APPLICATION NO.	FILING DATE	FIRST NAMED INVENTOR	ATTORNEY DOCKET NO.	CONFIRMATION NO.
10/066,926	02/04/2002	Michael Hahn	HAHN 3	4338
27964	7590	04/22/2004	EXAMINER	
HITT GAINES P.C. P.O. BOX 832570 RICHARDSON, TX 75083			MACCHIAROLO, PETER J	
			ART UNIT	PAPER NUMBER

Office Action Summary	Applicati n N .		Applicant(s) <i>M</i>	
	10/066,926		HAHN, MICHAEL	
	Examiner		Art Unit	
	Peter J Macchiarolo		2879

DETAILED ACTION

Figure 2

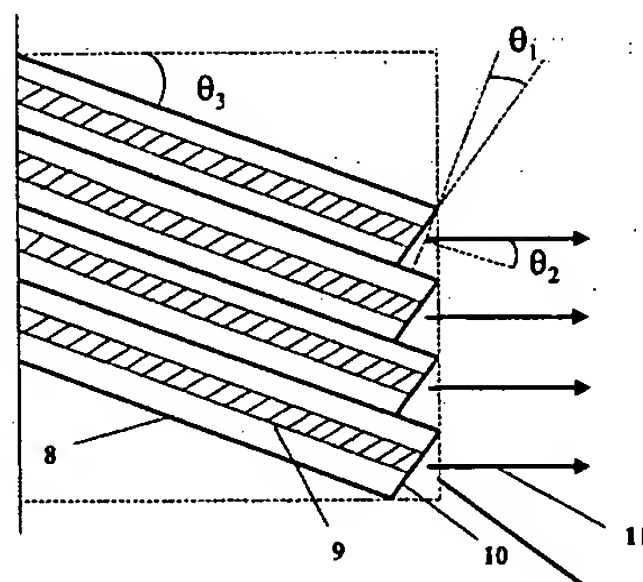
7. Claims 1, 6, 10, and 14 recite the electromagnetic energy is transmitted substantially normal to the waveguide array. However, the figures fail to show this configuration, but instead show the electromagnetic energy being transmitted askew to a transmitting face of the array, but normal to one of the dashed lines surrounding the array. Therefore, figure 2 leads the Examiner to believe that the dashed line is indeed the actual array with the substrates (8) being placed therein, as also inferred from the Summary of the Invention at page 3 of the instant Specification. “[A] substrate containing a plurality of substrate rows or layers.” If this is the case, the Examiner recommends adding a reference numeral to the dashed line to indicate the array such as illustrated below. Further, the claimed language, “normal to said waveguide array” is unclear. The Examiner reads, “normal to a transmitting face of said waveguide array.”

This is unclear. The Examiner reads, “aligned at an offset angle to a face of said waveguide array” as taught in Applicant’s figure 2 and page 3 of the instant Specification.

11. The refractive indices of the fiber optic cable and the waveguide array substrate are needed to calculate the refraction of the electromagnetic light at the fiber optic cable/waveguide array substrate interface, i.e. at the row face (fig. 2, 10), so the electromagnetic energy transmitted from each of the waveguide faces is substantially parallel to each other and substantially normal to a transmitting face of the waveguide array. However, instant specification and drawings are silent to these refractive indices, thereby not enabling one skilled in the art to properly make the array.
